#### Subject: LFPCN # 41278 - Glow Wire Compliance Upgrade for Holders and Blocks

Littelfuse Product Management would like to inform you that we are upgrading the insulation materials for our fuse holders and blocks that have VDE certification, in order to meet the enhanced glow wire requirements according to the updated standard IEC 60127-6. The new materials will be red phosphor free and halogen free. Meanwhile, we are consolidating IEC certifications with VDE.

### 814 Series

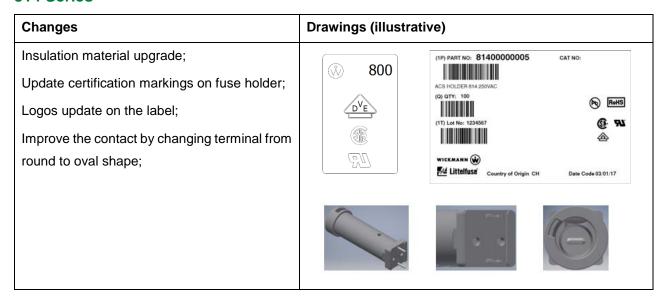
Drawings (illustrative)
(1P) PART NO: 8000000005 CAT NO:
ACS HOLDER 800 259/AC
(0) GTY: 100
(17) Let No: 1294967
WICKMANN 🚱
Littelflase Country of Origin: CH Date Code 83/91/17

### 820, 821, 823 & 824 Series

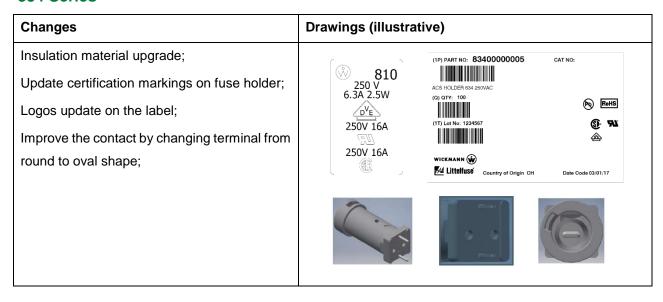
Changes	Drawings (illustrative)
Insulation material upgrade; Update certification markings on fuse holder;	250 V 6.3A/2.5W
Logos update on the label;	250V16A 250V16A
	(1P) PART NO: 8200000005 CAT NO:  ACS HOLDER 800 250VAC
	(a) GTY: 100 (b) RoHS (17) Lot No: 1234567 (g) 7%
	WICKMANN W  Littelfluse Country of Origin CH Date Code 03/01/17

#### 520 Series

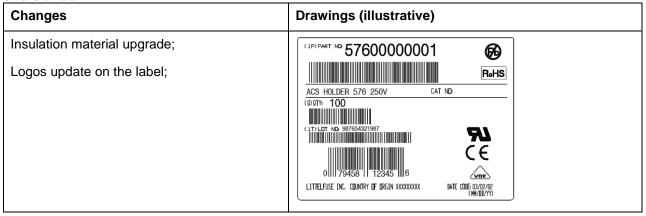
Changes	Drawings (illustrative)
Logos update on the label;	(IF) PARTINO 0 5 2 0 0 0 0 3 Z  ROBES  ACSINIL SHORE SHE SACRUEBLUR CATINO SASSESS  (Q OT: 1 0 0 0 0
